REMARKS

This application has been reviewed in light of the Office Action of April 8, 2004. Claims 1, 3-6 and 8-11 are pending in the application. By the present amendment, claims 1, 6, and 9 have been amended. Claims 2 and 7 have been canceled without prejudice. No new matter has been added. The Examiner's reconsideration of the rejection in view of the amendment and the following remarks is respectfully requested.

Ser. No. 10/007,157

Docket No.: PU010276

Fig. 1

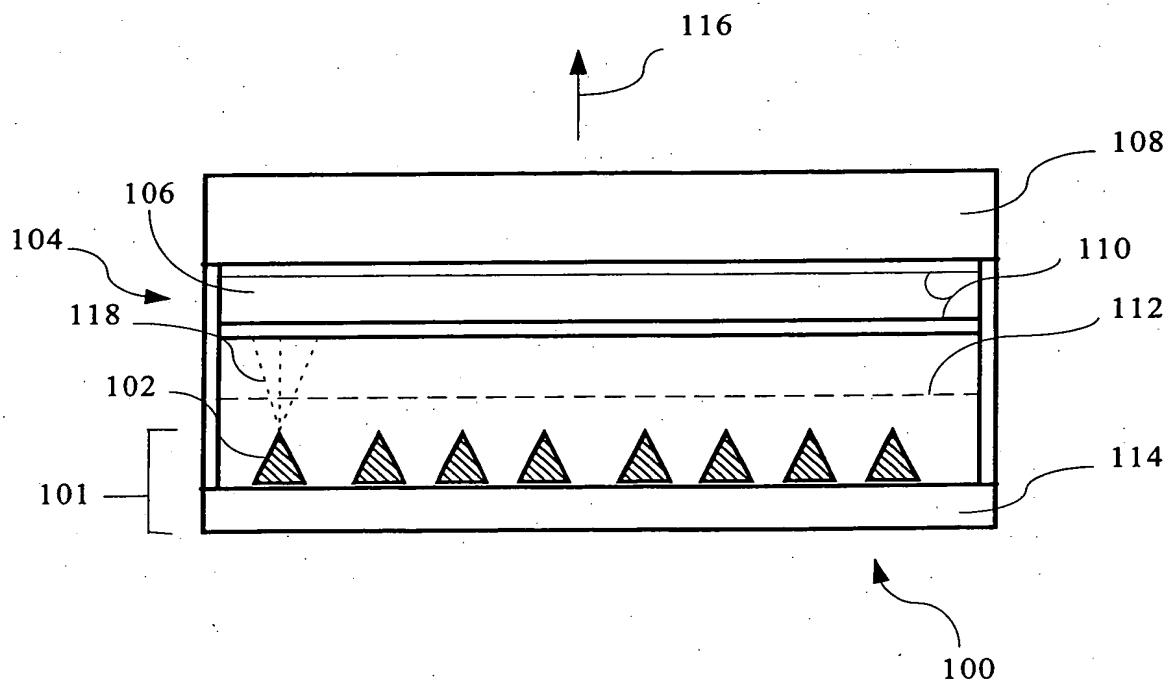
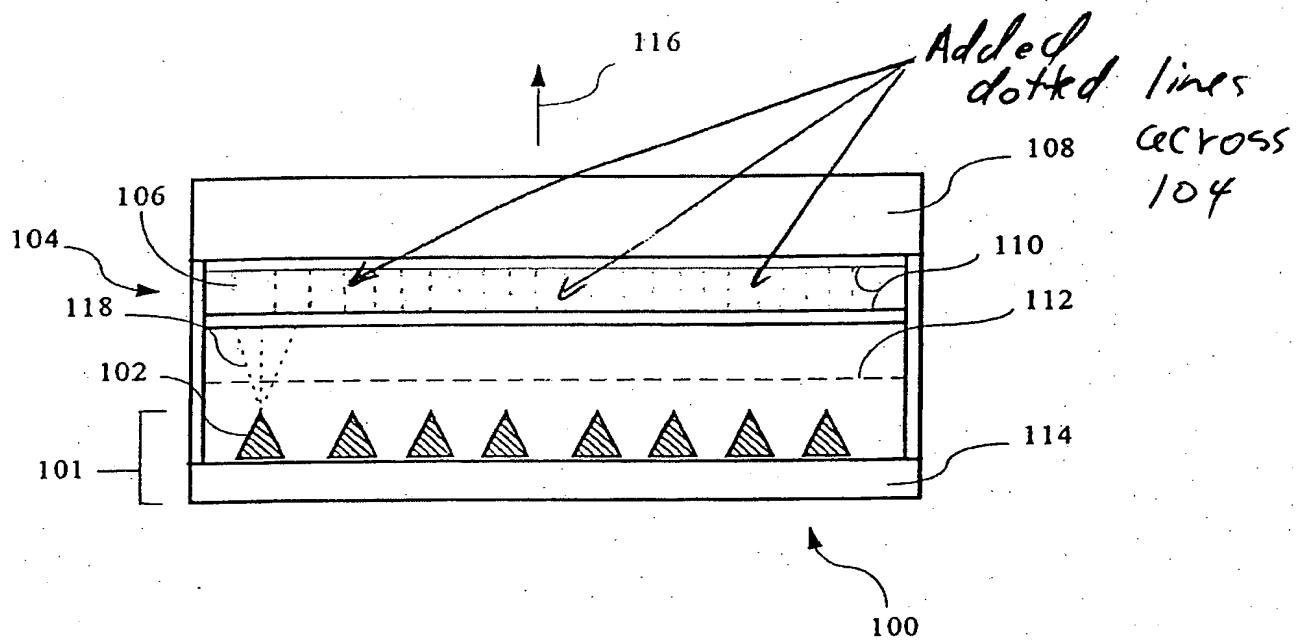
By the Office Action, the Examiner objected to the drawings as not showing every feature as specified in the claims, namely "an array of resonant microcavity anodes" as claimed in claim 6. The Applicants respectfully disagree with the rejection.

FIG. 1 shows a microcavity anode 104 for a resonant microcavity anode (RMA) type field emission display (FED) device. The array of anodes is included in the layer 104 as can be seen from FIGs. 13a and 13b in U.S. Patent No. 5,804,919 to Jacobsen et al. (hereinafter Jacobson), which was incorporated by reference. FIG. 1 has been amended to show a portion of layer 104 as an array of anodes. Therefore it is respectfully submitted that the claimed feature of "an array of resonant microcavity anodes" is now presented in the FIGS. A new FIG. 1 and a marked-up version are submitted herewith showing dotted lines in anode layer 104 to show an array of anodes. Support is found in Jacobsen as referenced above. No new matter has been added. Reconsideration is respectfully requested.
